UNITED STATES
NUCLEAR REGULATORY COMMISSION
WASHINGTON, D.C. 20555-0001
August 31, 2015

SUBJECT: GRAND GULF NUCLEAR STATION, UNIT 1 - ISSUANCE OF AMENDMENT
REGARDING MAXIMUM EXTENDED LOAD LINE LIMIT ANALYSIS PLUS
(TAC NO. MF2798)

The license amendment request (LAR) (Reference 1), proposes a revision to the GGNS TSs to allow plant operation from the currently licensed Maximum Extended Load Line Limit Analysis (MELLLA) domain to plant operation in the expanded MELLLA Plus (MELLLA+) domain under the previously approved extended power uprate (EPU) conditions of 4408 megawatts thermal (MWt) rated core thermal power.

Figure 1. MELLLA+ Operating Domain for GGNS

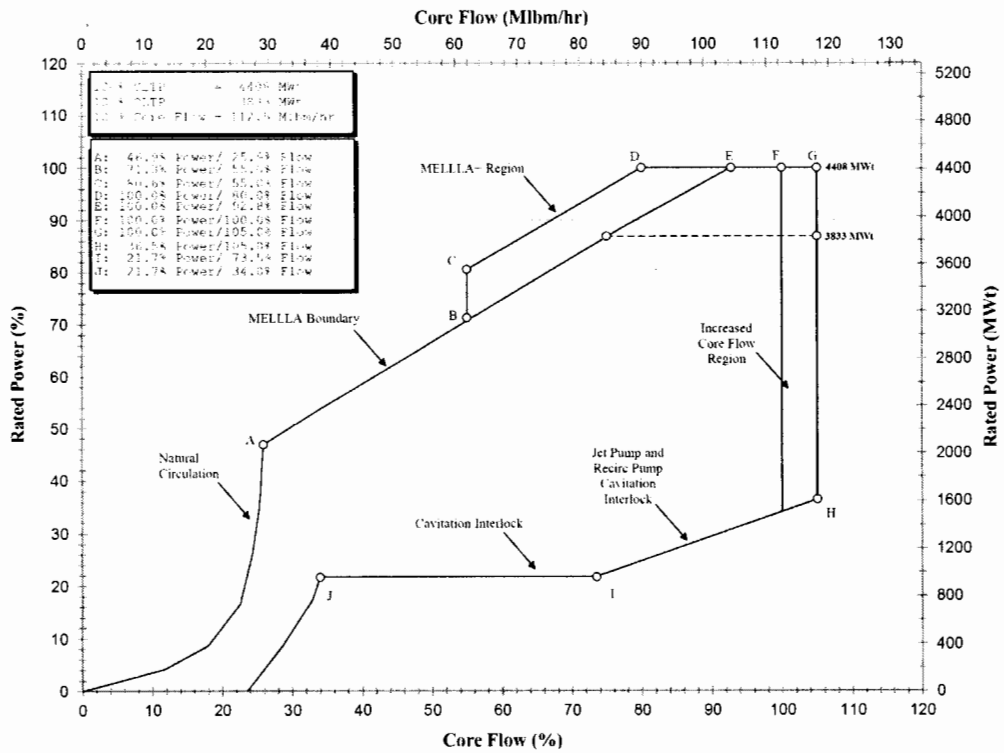
Table 1-1 of the GGNS's SAR lists all of the computer codes used in the MELLLA+ SAR evaluations. Figure 1-1 of the SAR (reproduced here as Figure 1 below) defines the MELLLA+ operating domain.

(The upper boundary of the domain is defined by the following relation between the power (P), and the percent core flow (W_T), where the GGNS plant-specific lower limit for W_T is 54%.)
 $(P = 100 + 0.7749 (W_T - 80\%))$

Figure 2. Illustration of Power-to-Flow Ratio Requirements from Limitation 9.3

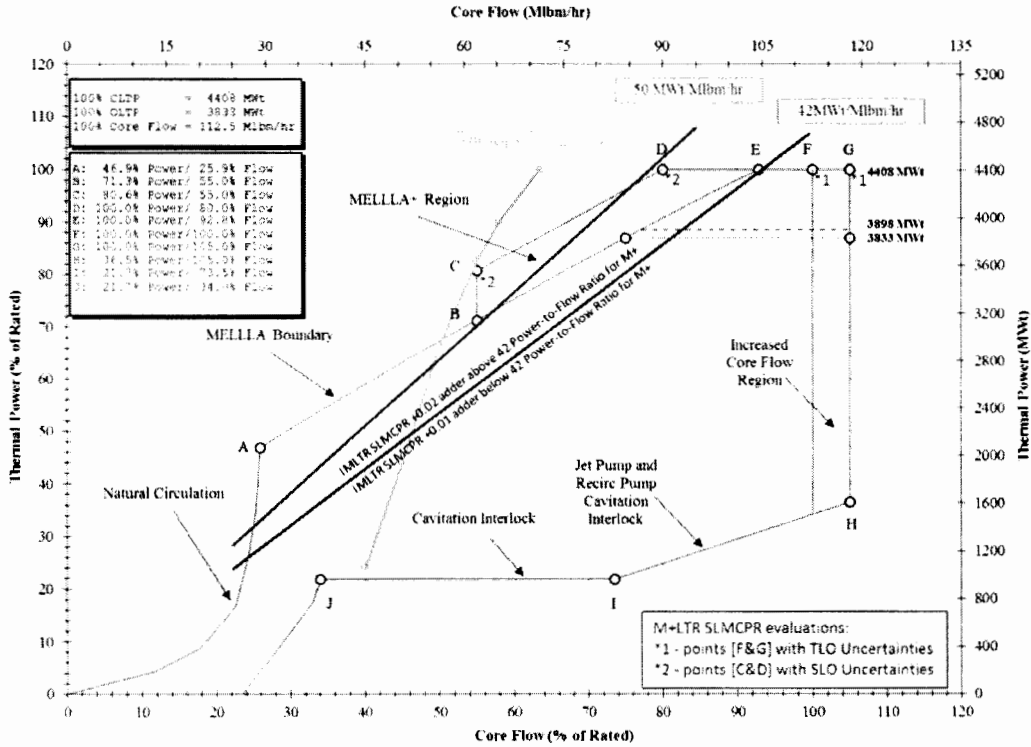
For operation at power-flow greater than 50 MWt/Mlbm/hr (for example, at point C in Figure 2, above), the NRC staff SER required a case-specific evaluation to ensure that the particular plant is not an outlier and has unusual uncertainty values. The NRC staff also required an additional penalty on the SLMCPR by using SLO uncertainties, even though SLO operation is not allowed under MELLLA+. This restriction applies to Point C and D in Figure 2. For GGNS Cycle 20 (the first MELLLA+ implementation), use of the SLO flow uncertainties is estimated to increase the TLO SLMCPR from 1.11 to 1.15, equivalent to a 0.04 SLMCPR penalty, which is quite significant.

In addition to the 42 and 50 power-to-flow lines (red lines), Figure 2 shows the line in the power-to-flow map where the TIP exit void fraction in the bypass region is 5 percent (orange line). Bypass void fractions can affect the calibration of LPRM or TIP detectors because they are calibrated at full power where there is no bypass voiding. The MELLLA+ SER (Reference 30) requires that the bypass void fraction be lower than 5 percent to prevent the decalibration issues. The calculation shown in Figure 2 confirms that bypass voiding is not a problem in GGNS operating in the MELLLA+ domain.

Figure 3. Location in Power to Flow Map of Available TIP Data

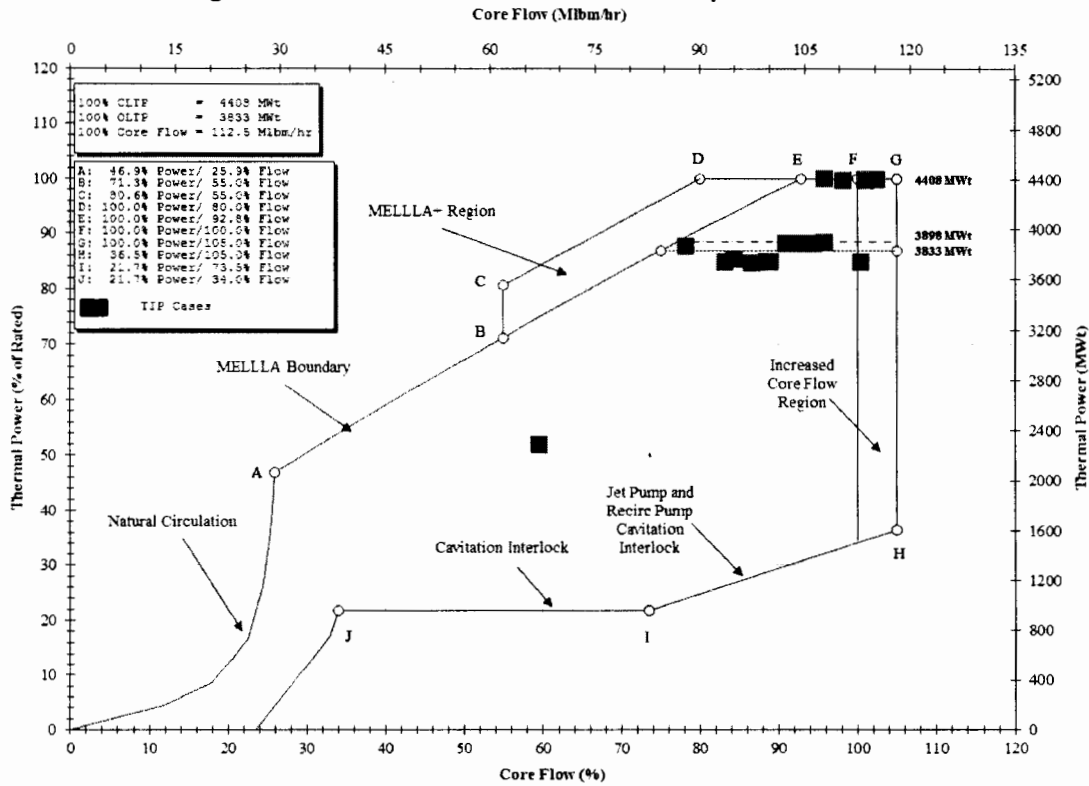
Figure 3 shows the locations in the power-to-flow map where TIP measurements were performed in GGNS for the last three cycles (18-20). Measurements have been taken in GGNS with power densities as high as 44.07 MWt/MIbm/hr. Analyses of these data show that the power distribution root mean squared error is <1 percent, with the error increasing towards end of cycle, but < 1.5 percent for all points.
